Project	IEEE 802.16 Broadband Wireless Access Working Group <http://ieee802.org/16>	
Title	BPSK Modulation for IEEE 802.16 WirelessMAN™ OFDM	
Date Submitted	2004-03-12	
Source(s)	Atul Salvekar Hassan Yaghoobi	Voice: 408-545-9577, Fax: 408-545-9888, mailto: atul.a.salvekar@intel.com Voice: 408-545-6162, Fax: 408-545-9898, mailto: hassan.yaghoobi@intel.com
	Intel Corporation CHP3-105 350 East Plumeria Dr. San Jose, CA 95134	
	Vladimir Yanover	Voice: +972-36457834 , Fax : +972-36456222, mailto: vladimir.yanover@alvarion.com
	Alvarion Ltd. 21 A Habarzel St. Ramat - Hahayal Tel - Aviv 69710 P.O. Box 13139, Tel-Aviv 61131, Israel	
Re:	Supporting document for Sponsor Ballot	
Abstract	In P802.16 REVd/D3 [1], both Single-Carrier and OFDMA PHY modes use BPSK as a robust type of modulation recommended for data and/or control channels. Currently OFDM-PHY supports robust modes of operations such as AAS and STC only on data channels and not on the control channels. To achieve true link budget enhancement expected from these optional modes of operation, it is proposed to make BPSK modulation mandatory on the FCH portion of the channel and optional on the data portion. The RNG-REQ message format h

Change 6:

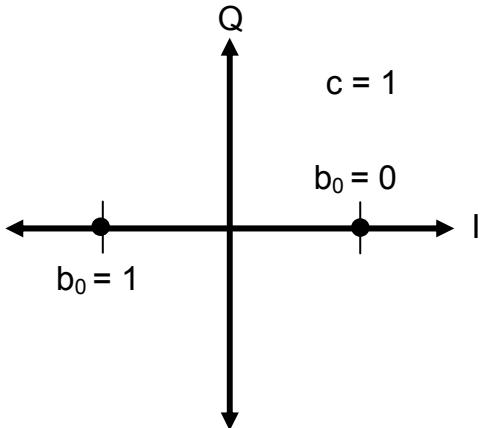
On page 416, Figure 197, add BPSK as follows to the set of constellation options:

Also change the caption on Figure 197 accordingly and as follows:

“BPSK, QPSK, 16-QAM and 64-QAM constellations”
